**Town of Tecumseh
MRSPA SWM
Environmental Study
Report Addendum**

*December 2014 – Submitted for Public and Agency
Review*

April 2015 – FINAL REPORT

**Finalized Addendum to Class Environmental Assessment
Manning Road Secondary Plan Area (MRSPA)
Stormwater Management Study**

FIGURE 3.0
PROPOSED SITE GRADING
FOR OVERLAND FLOOD ROUTE

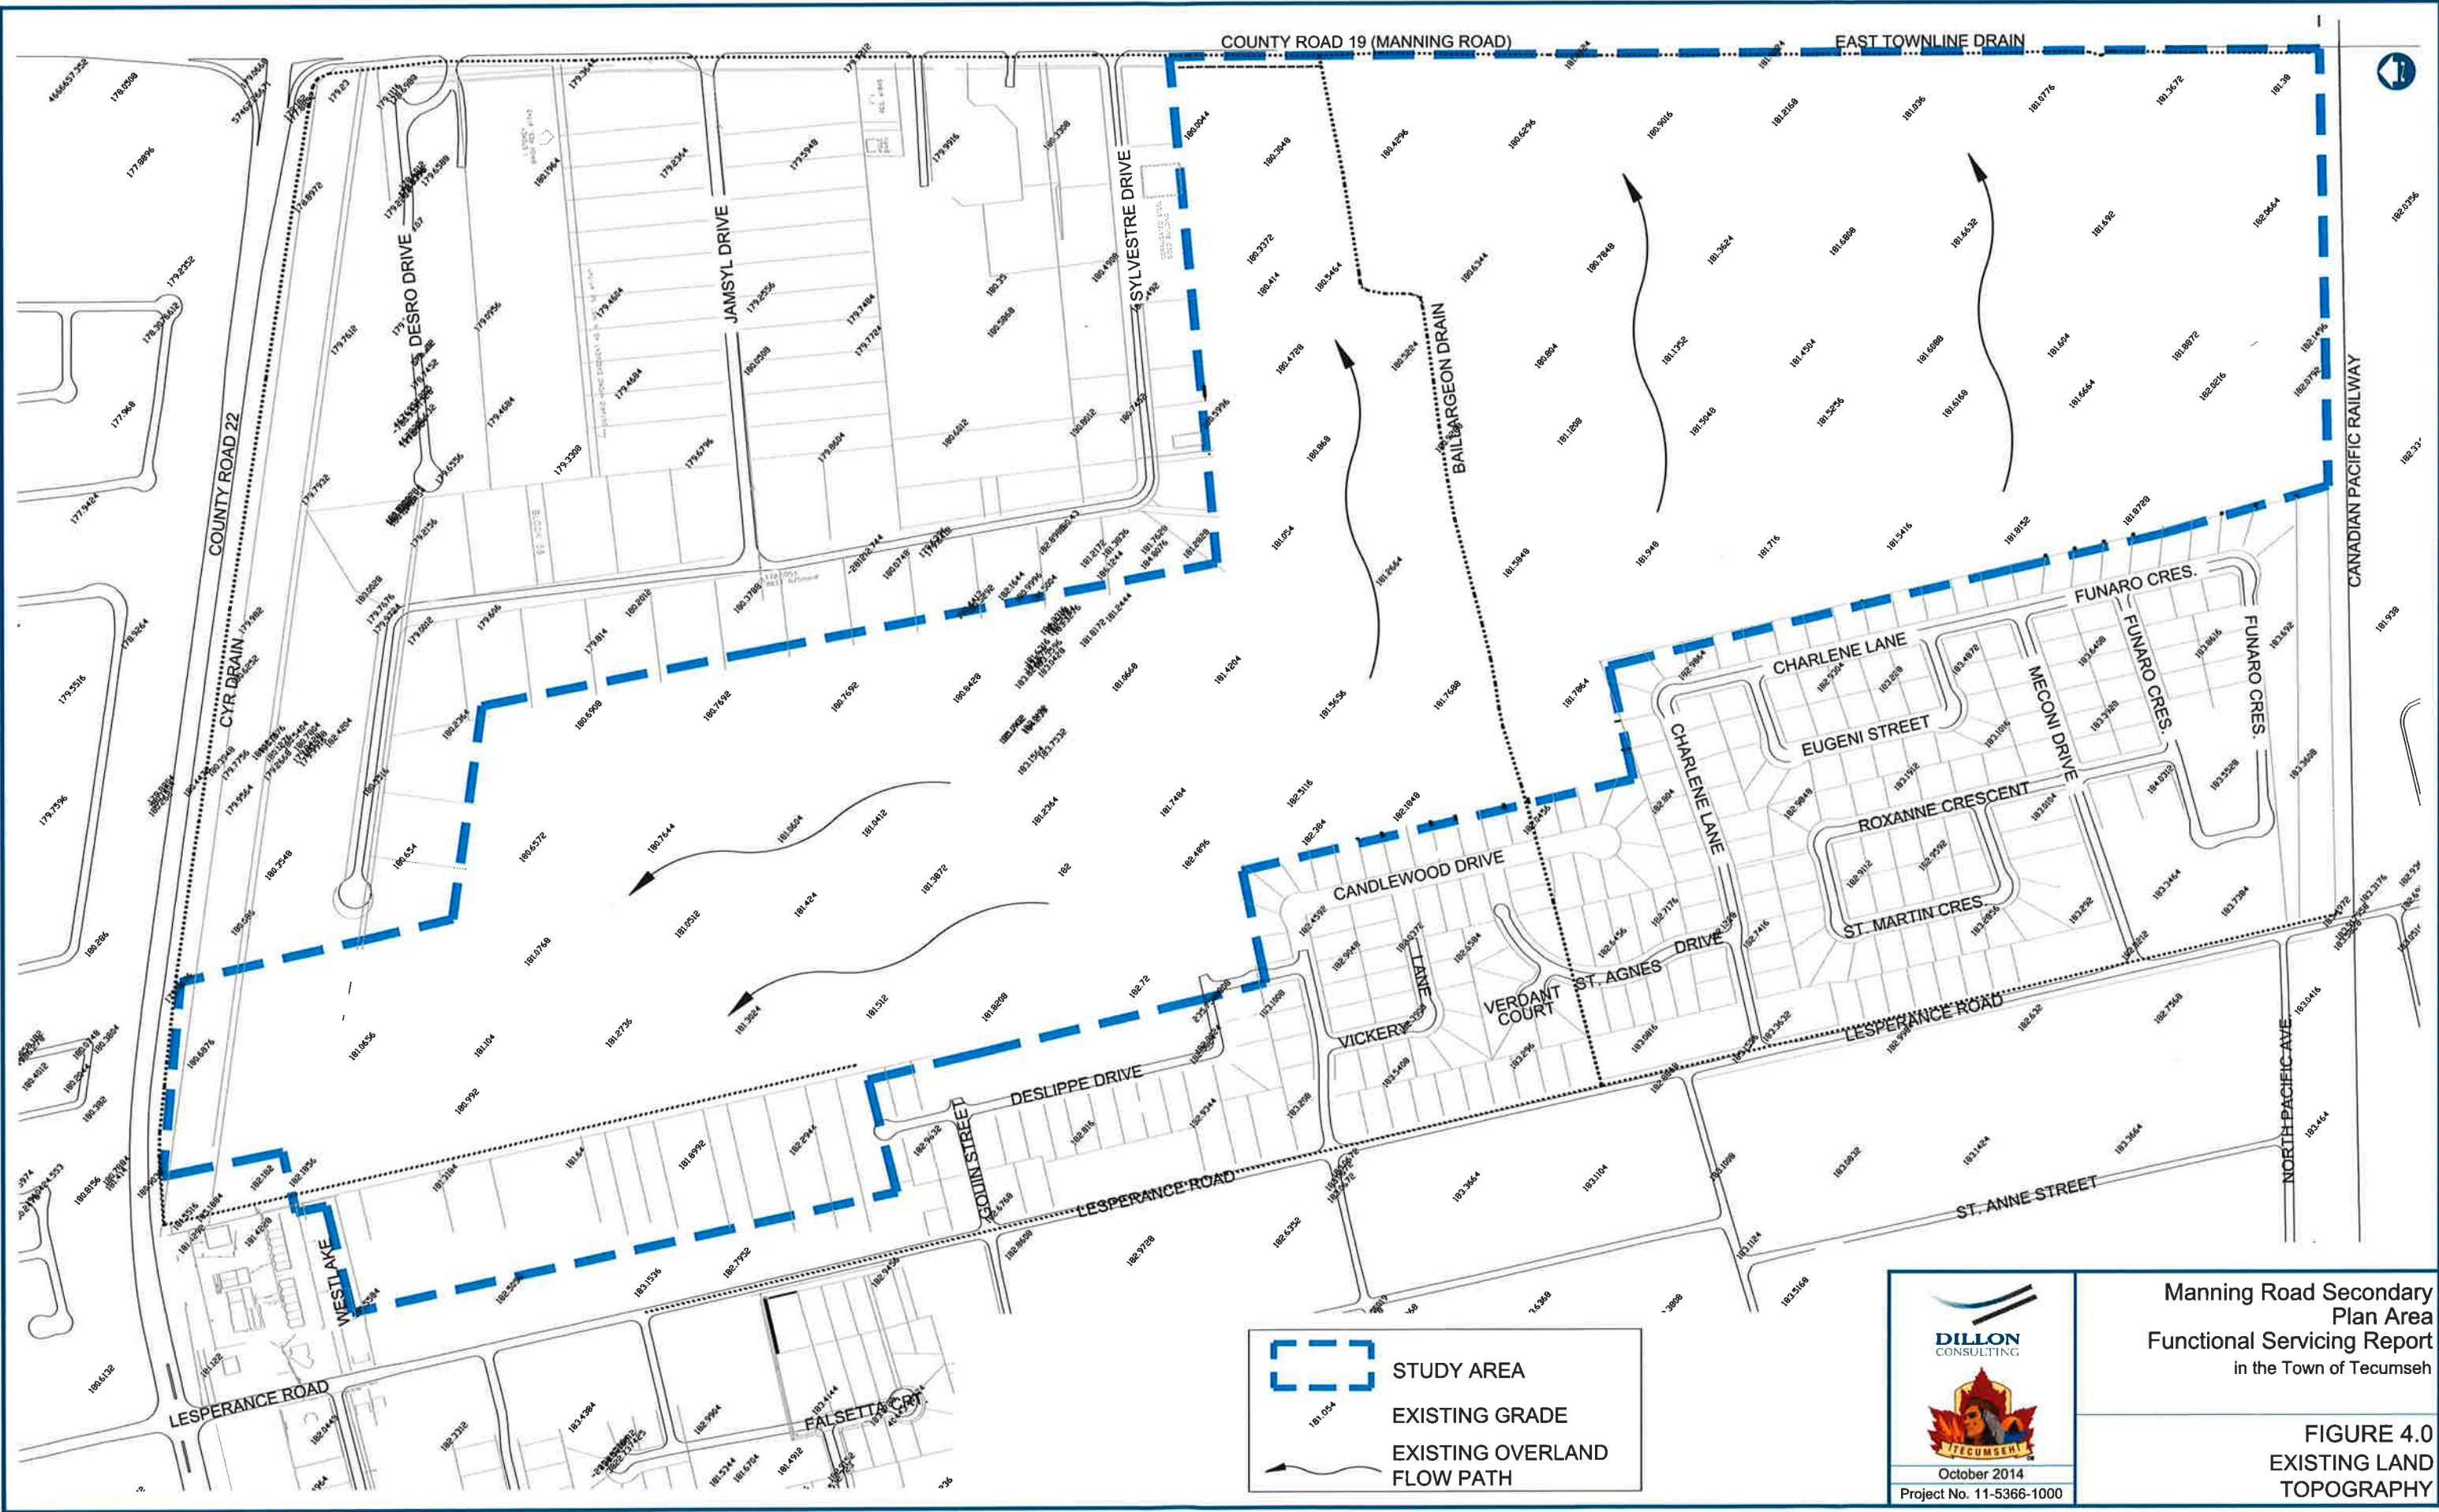
1. In Table 2, the lowest proposed MRSPA surface elevation is noted as 180.750 m. On Figure 3 the lowest surface elevation appears to be 180.700 m and on Figure 9 it appears to be 180.650 m. Please confirm. In addition, the road elevations shown on Figures 7 and 8 are not readable. Please confirm that all road elevations used in the modelling and shown on the Figures are consistent.

- c. Numerous figures/plots are provided in Appendix B. Tabular presentation of some of this information would be helpful.
- d. The proposed road grade elevation shown at the north end of the site in Figure 3 (low elevation = 180.650 m) does not appear to match the existing grade elevations shown on the truck sewer profile plots in Appendix A. In addition, the plotted HGL appears to be above the proposed road grade elevation.

FIGURE 11.0
 INTERIM
 STORM CONDITIONS

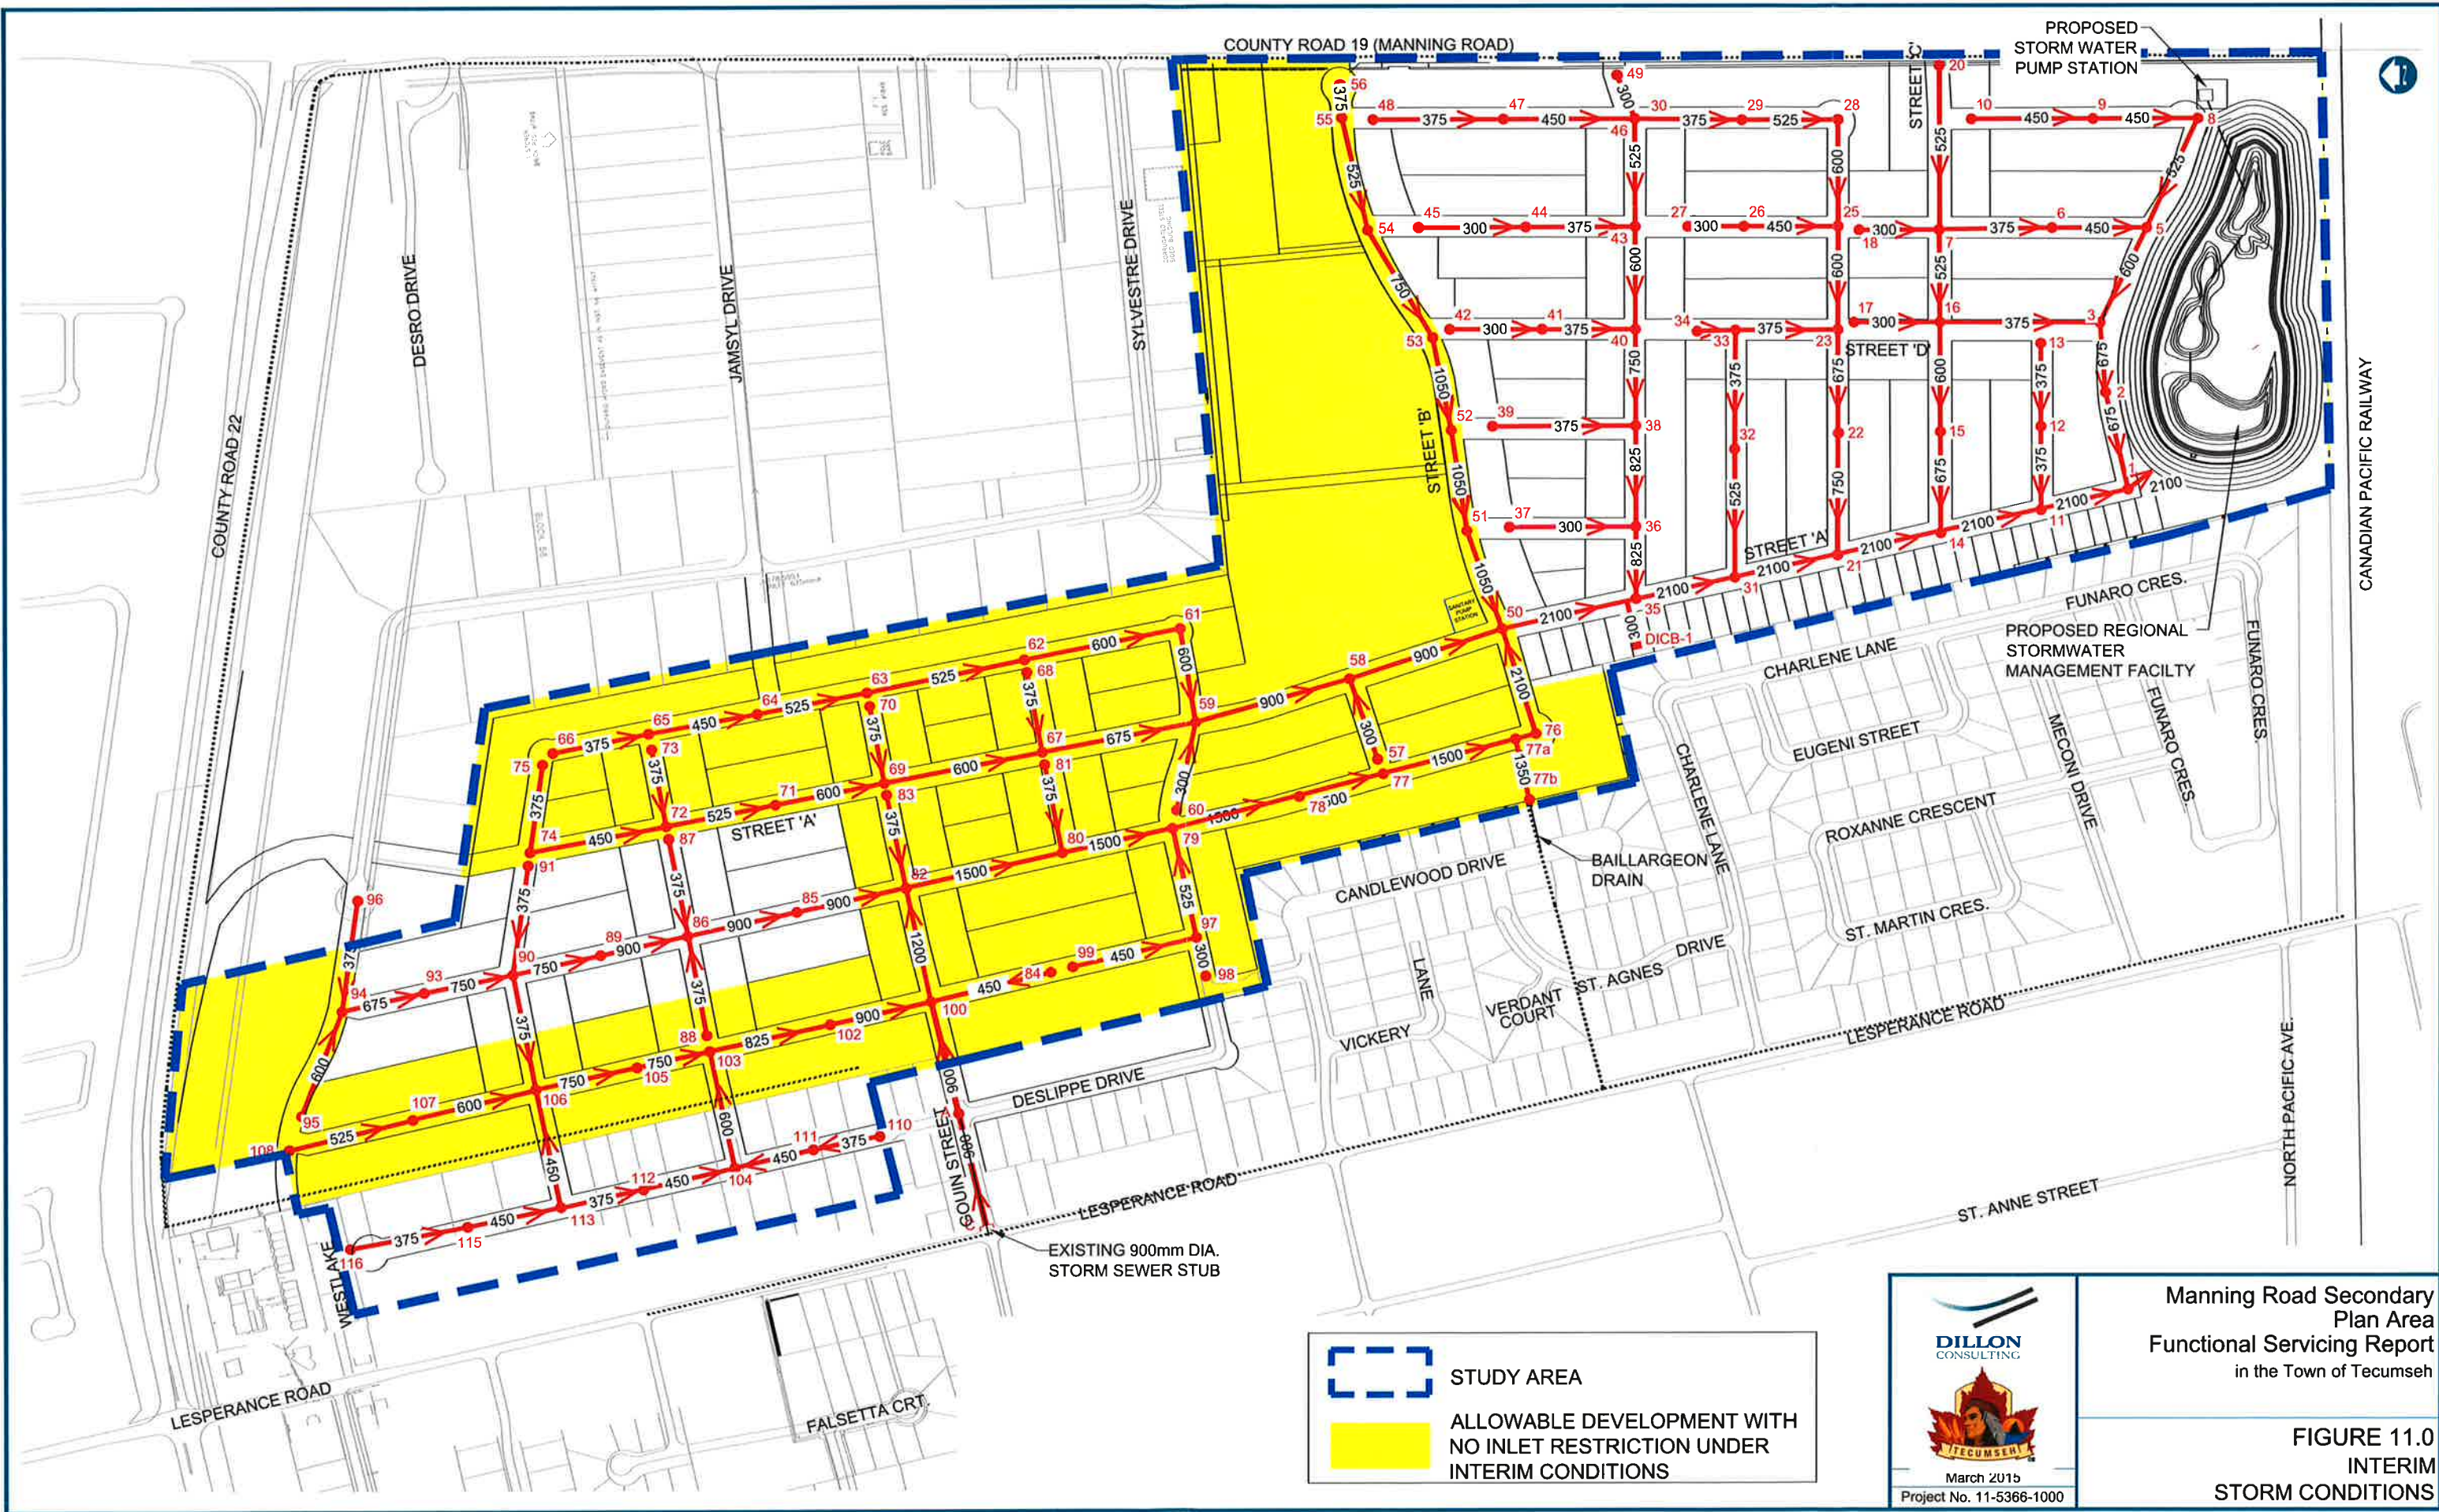
7. The storm sewer layout and pipe diameters used in the analysis are shown in Figure 11.0. To ensure consistency as development proceeds in this area, the storm sewer slopes and inverts used in the analysis should also be included. We recommend that your preliminary storm sewer design sheets be included to be used as a guide for future design of the individual developments.

- Drawings of the pond geometry, including dimensions and typical cross sections are provided within Figure 15 & Figure 16 of the MRSPA Class EA Study Report (April 2010), which has been referenced in our Addendum report. No changes to the proposed MRSPA pond have been identified as part of this Addendum report.
 - 7. The storm sewer layout and pipe diameters used in the analysis are shown in Figure 11.0. To ensure consistency as development proceeds in this area, the storm sewer slopes and inverts used in the analysis should also be included. We recommend that your preliminary storm sewer design sheets be included to be used as a guide for future design of the individual developments.
